Prairie Island Nuclear Generating Plant Units 1 and 2
Dockets 50-282 and 50-306
License Nos. DPR-42 and DPR-60

License Amendment Request (LAR) to Revise the Spent Fuel Pool Criticality Analyses and Technical Specifications (TS) 3.7.17, "Spent Fuel Pool Storage" and 4.3, "Fuel Storage"

License Amendment Request (LAR) to Revise the Spent Fuel Pool Criticality Analyses and Technical Specifications (TS) 3.7.17, "Spent Fuel Pool Storage" and 4.3, "Fuel Storage"

Figure ~~IGURE~~ 4.3.1-2
Spent Fuel Pool Checkerboard Interface Requirements

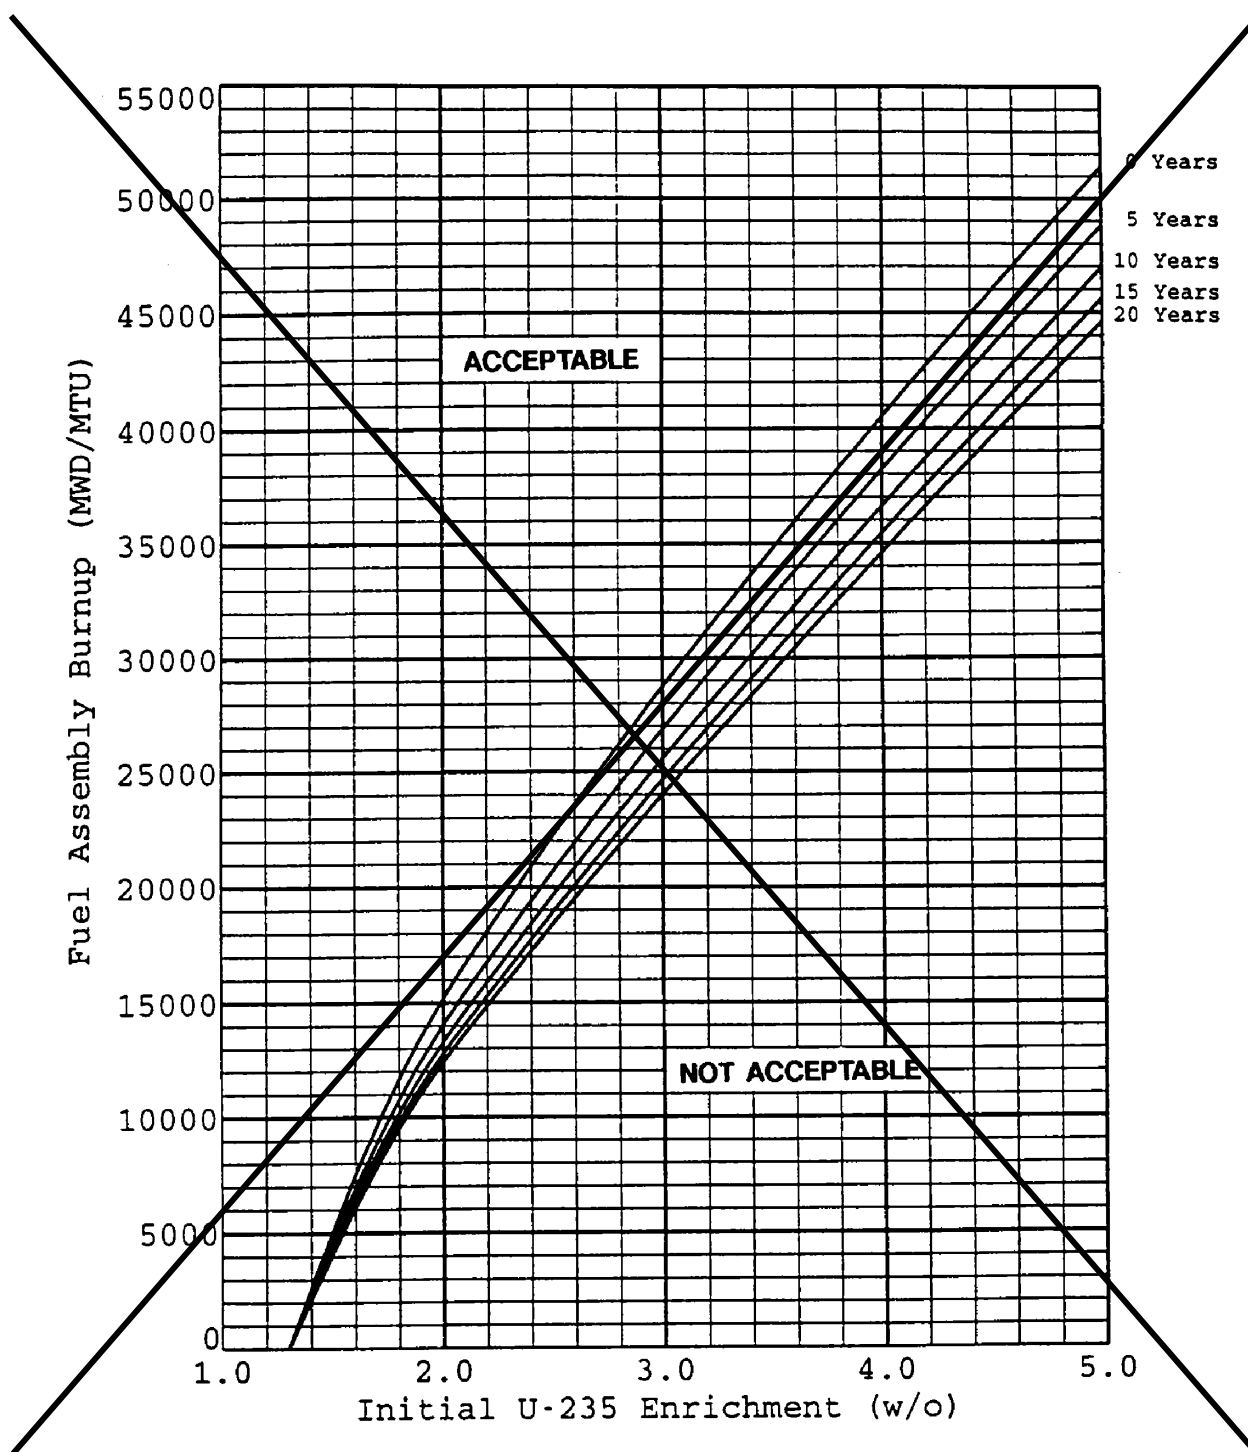
Use Figure based on Westinghouse Calculation CN-WFE-03-40 Figure 4-6

Figure 4.3.1-4

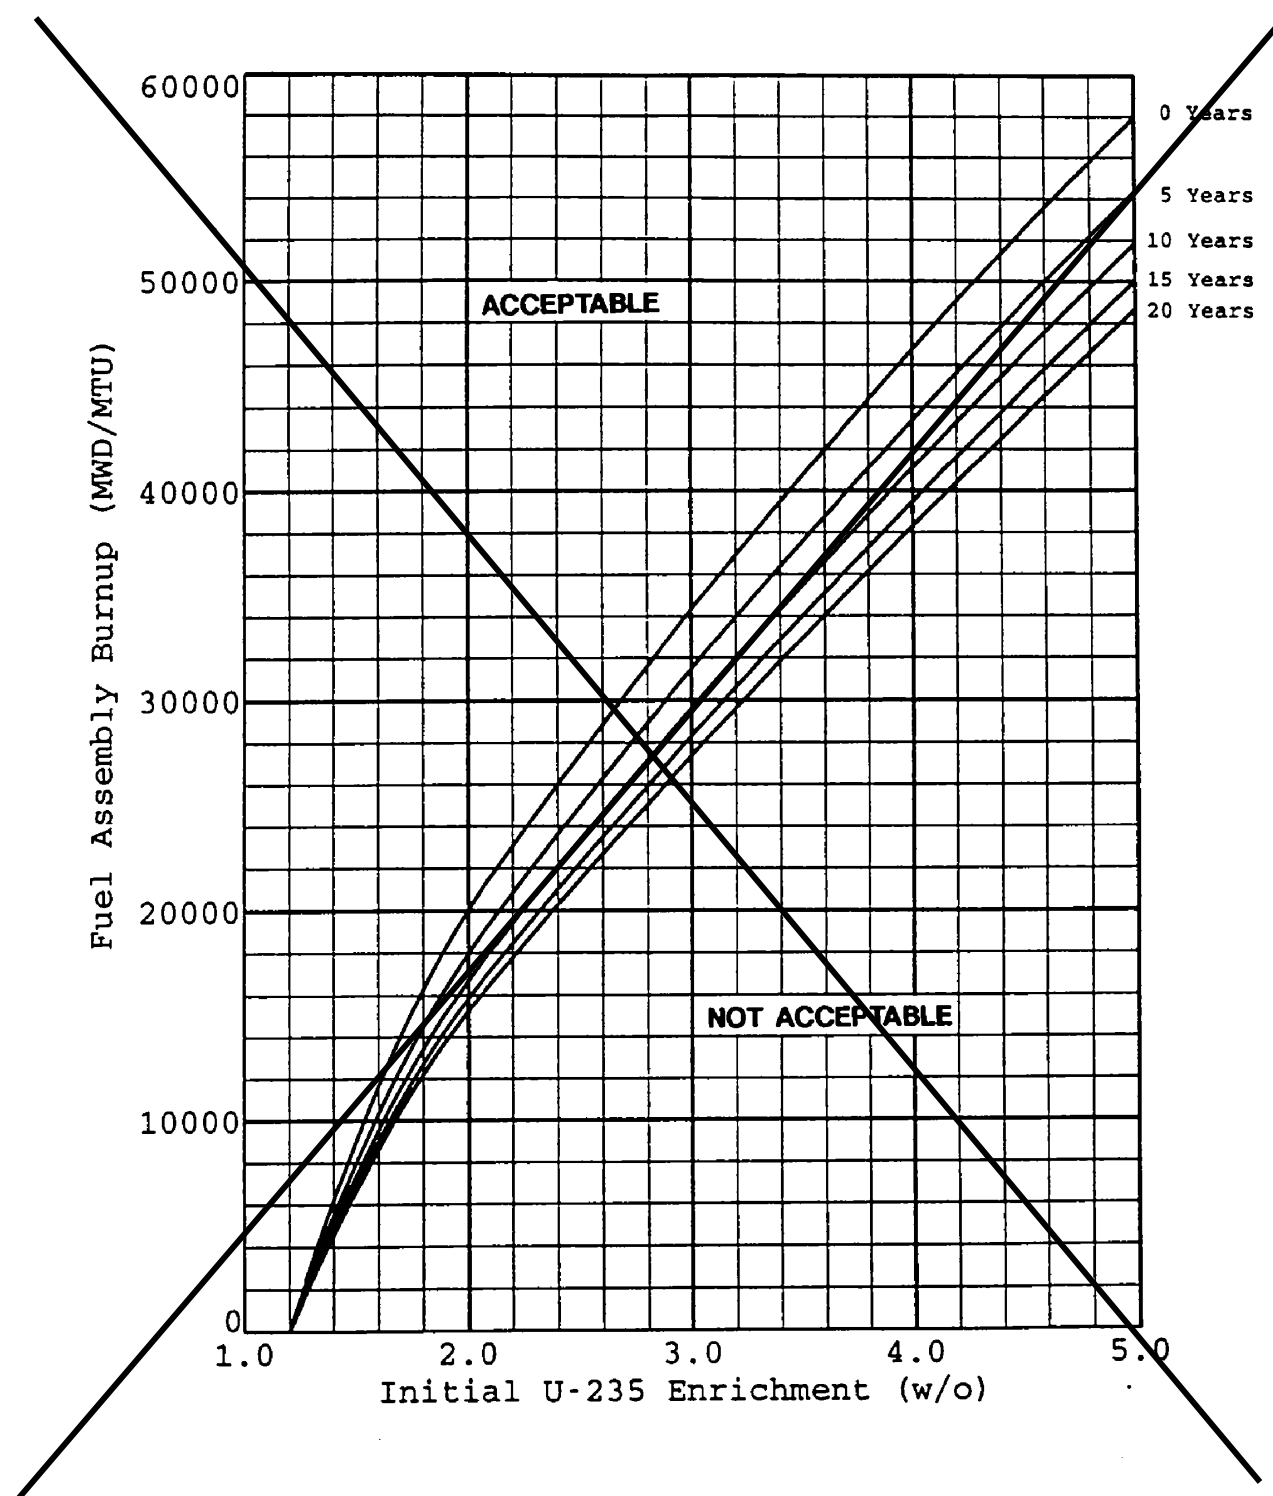
Spent Fuel Pool Checkerboard Region Burnup and Decay Time Requirements - ~~STD~~ Fuel, with No GAD

FIGURE 4.3.1-5 Spent Fuel Pool Checkerboard Region Burnup and Decay Time Requirements—OFA Fuel, 4 GAD

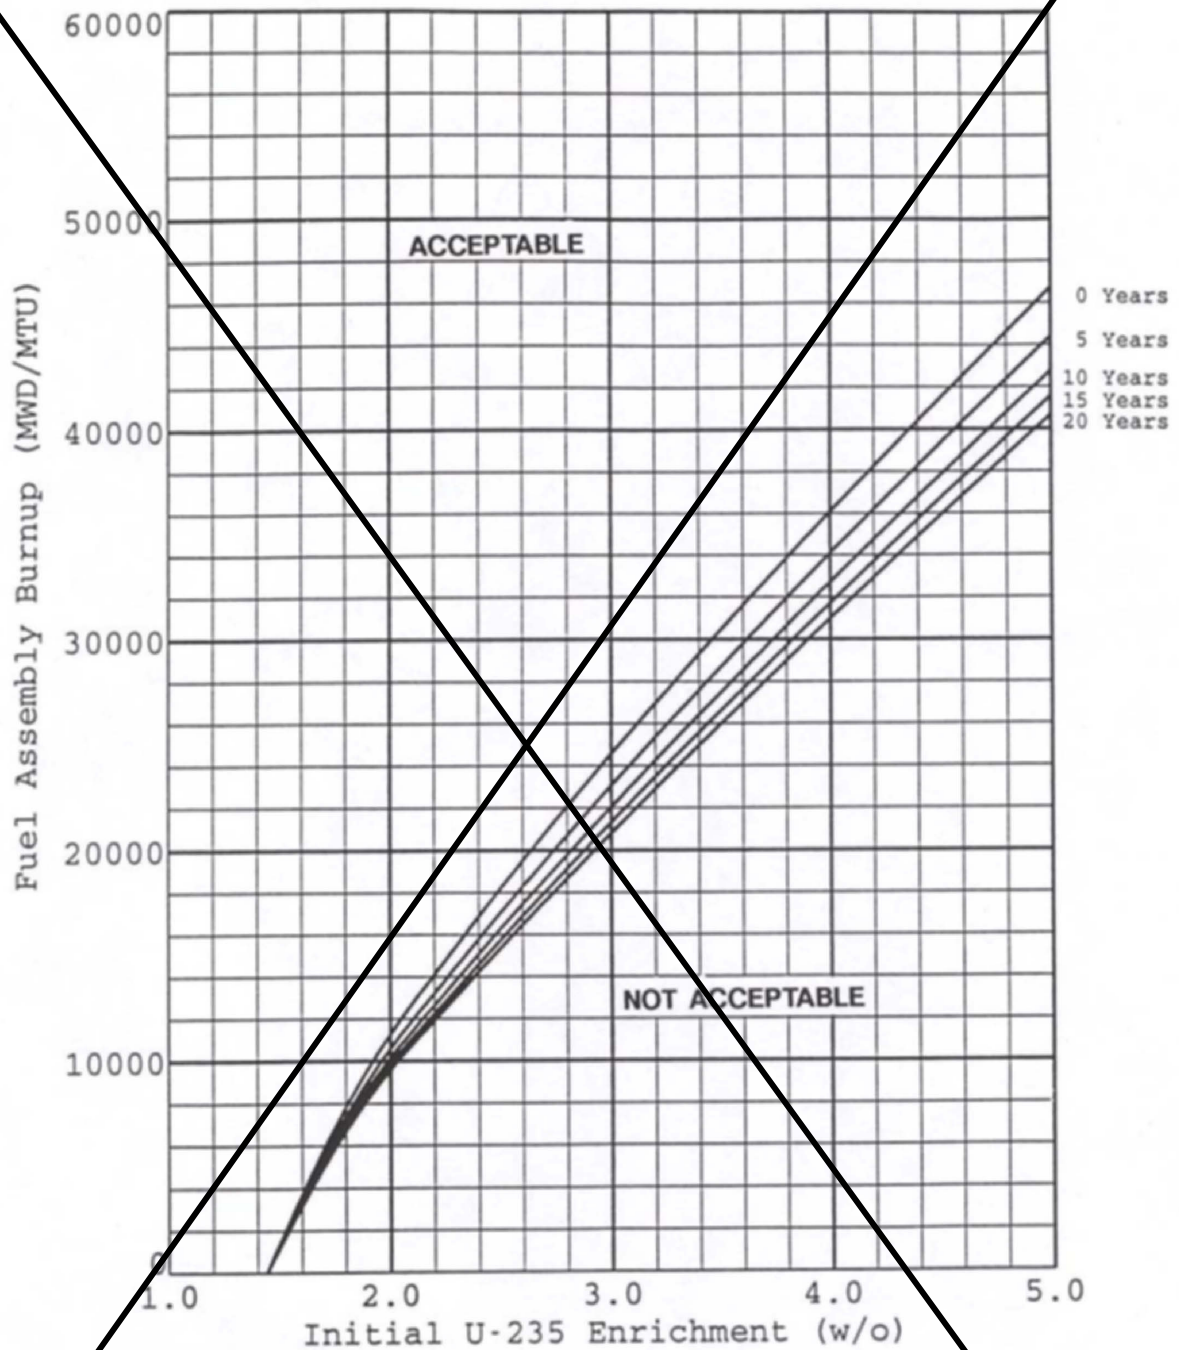
Figure deleted

FIGURE 4.3.1-6 Spent Fuel Pool Checkerboard Region Burnup and Decay Time Requirements—STD Fuel, 4 GAD

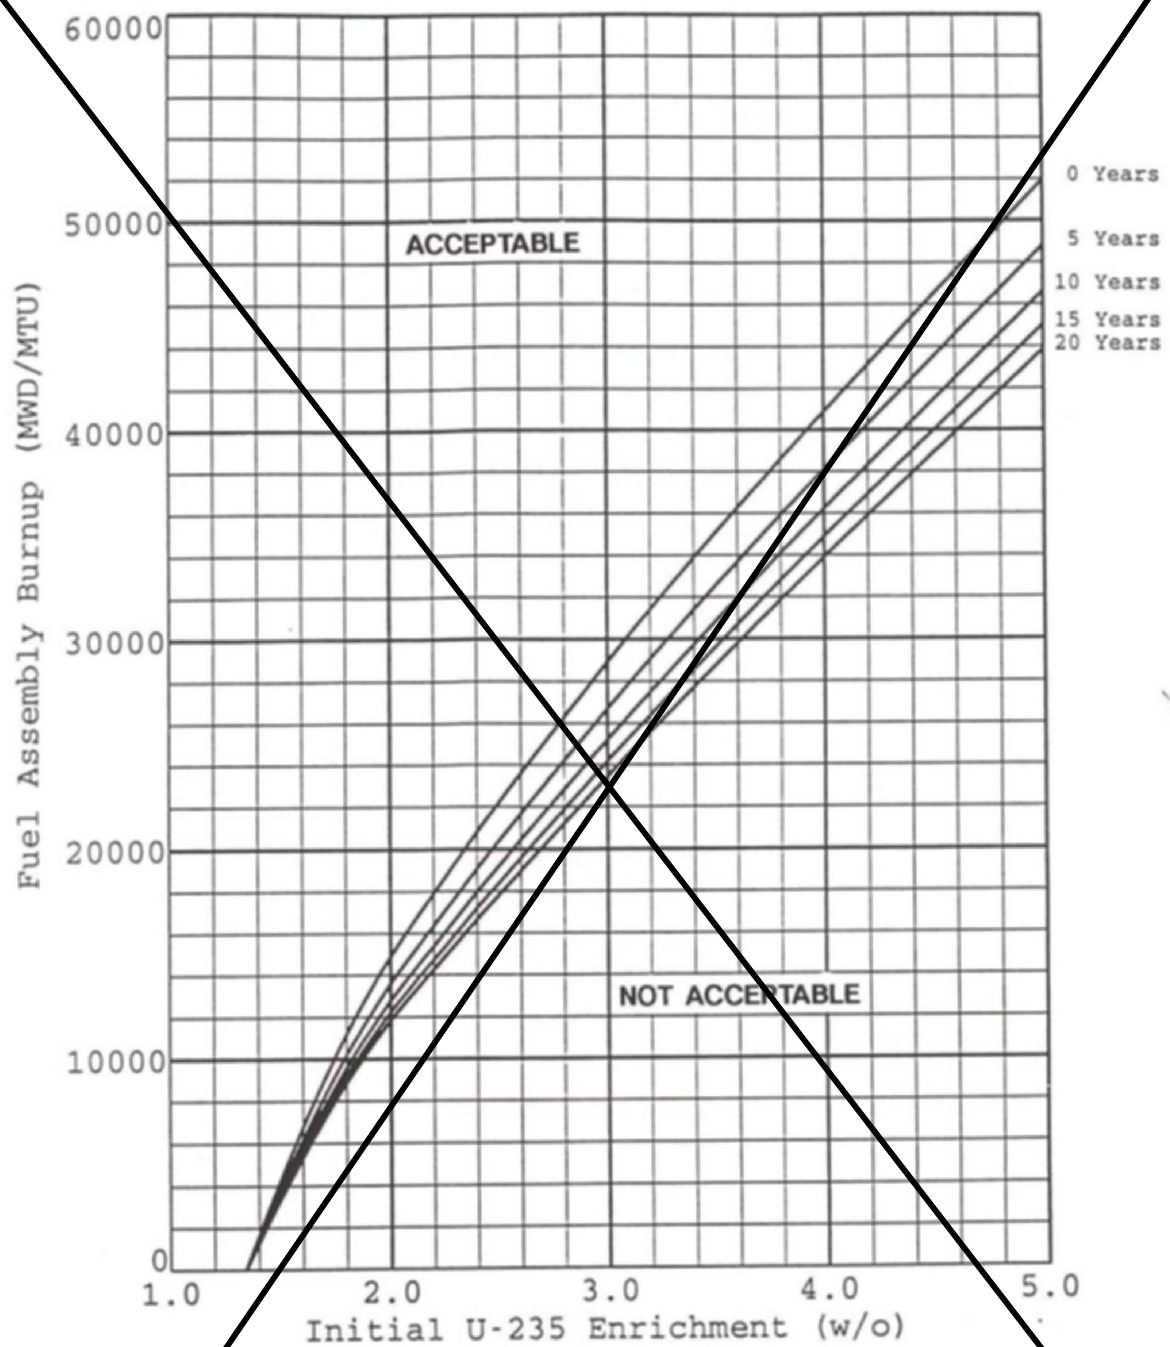
Figure Deleted

FIGURE 4.3.1-7 Spent Fuel Pool Checkerboard Region Burnup and Decay Time Requirements—OFA Fuel, 8 GAD

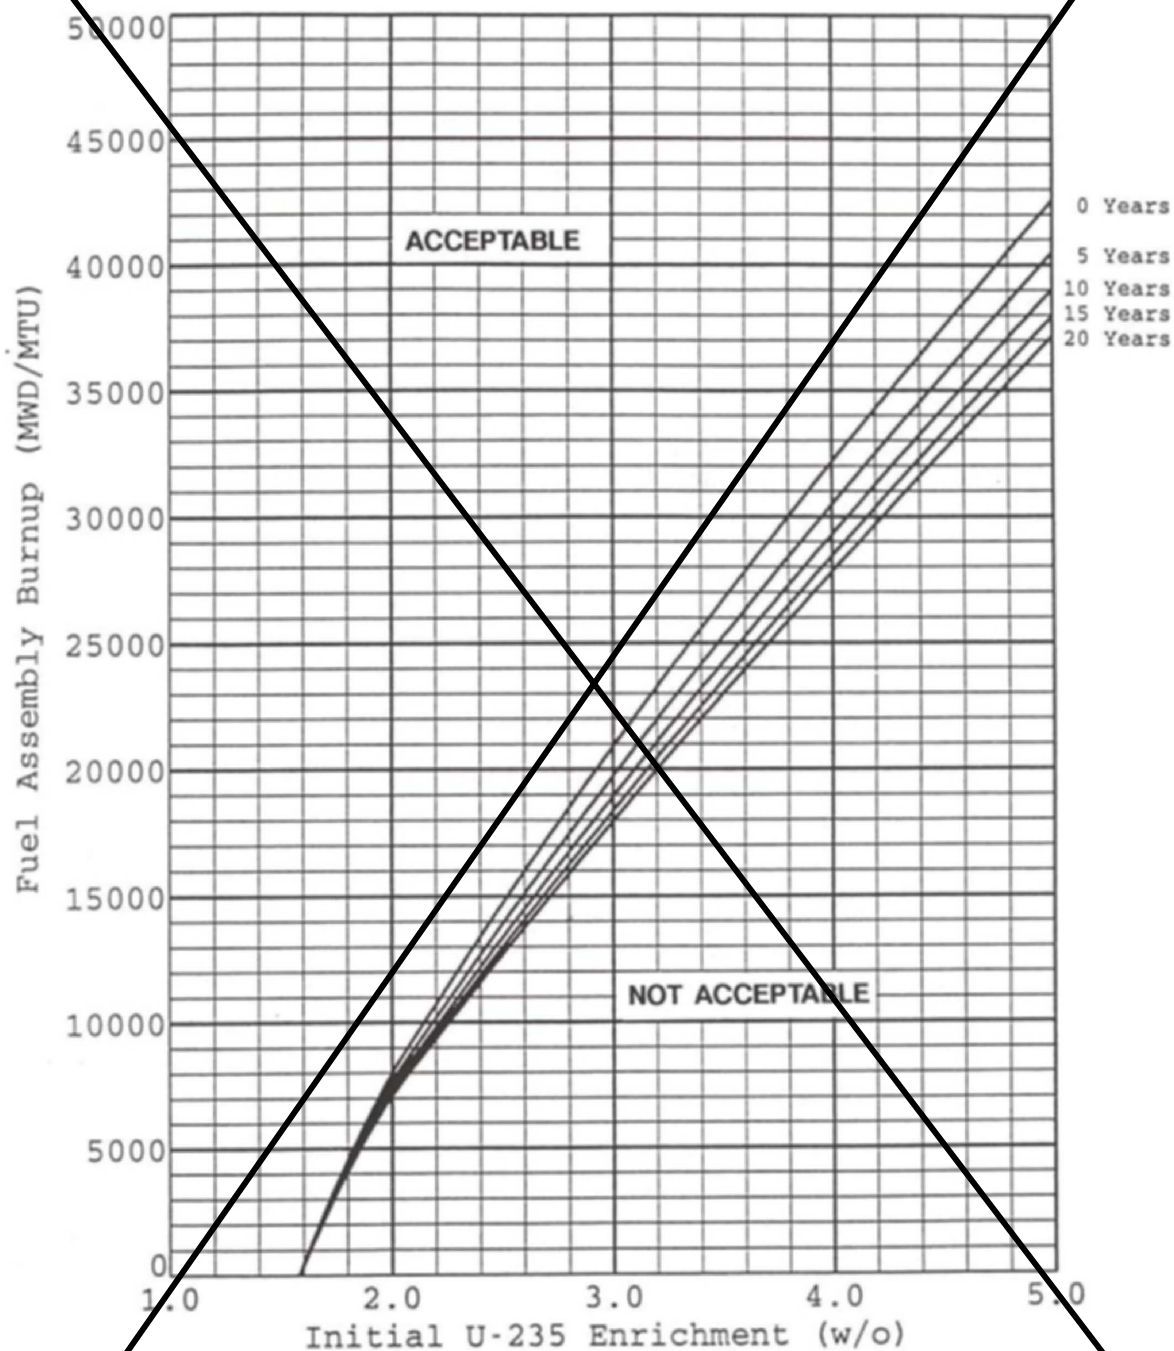
Figure deleted

FIGURE 4.3.1-8 Spent Fuel Pool Checkerboard Region Burnup and Decay Time Requirements—STD Fuel, 8 GAD

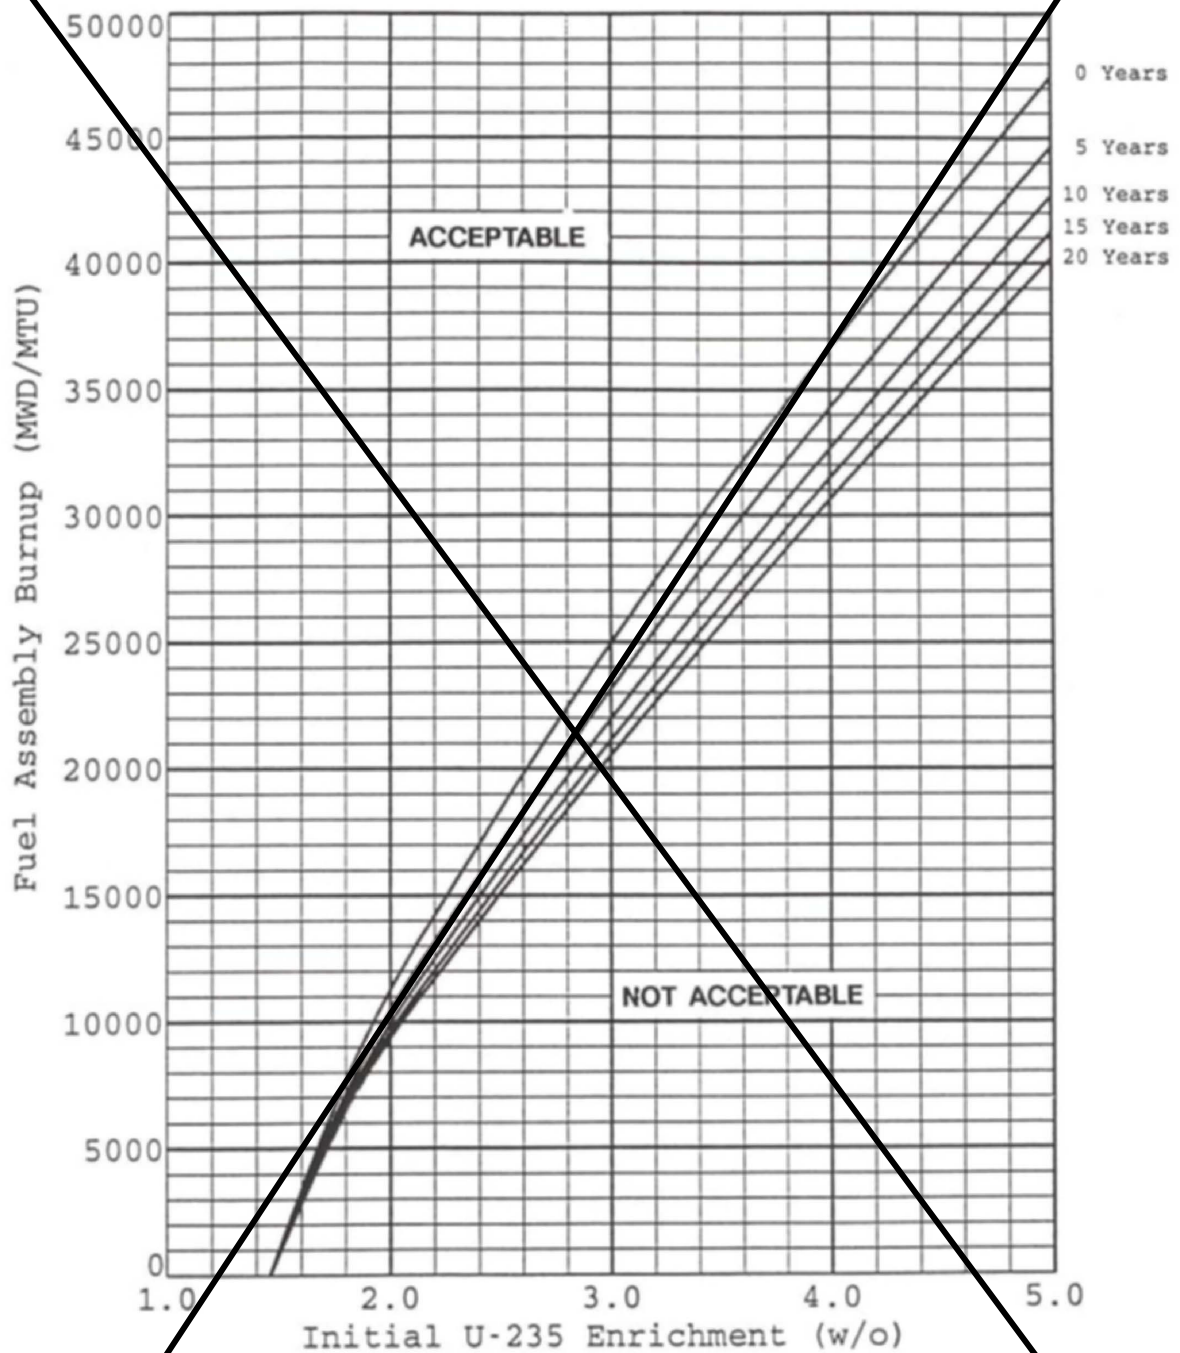
Figure deleted
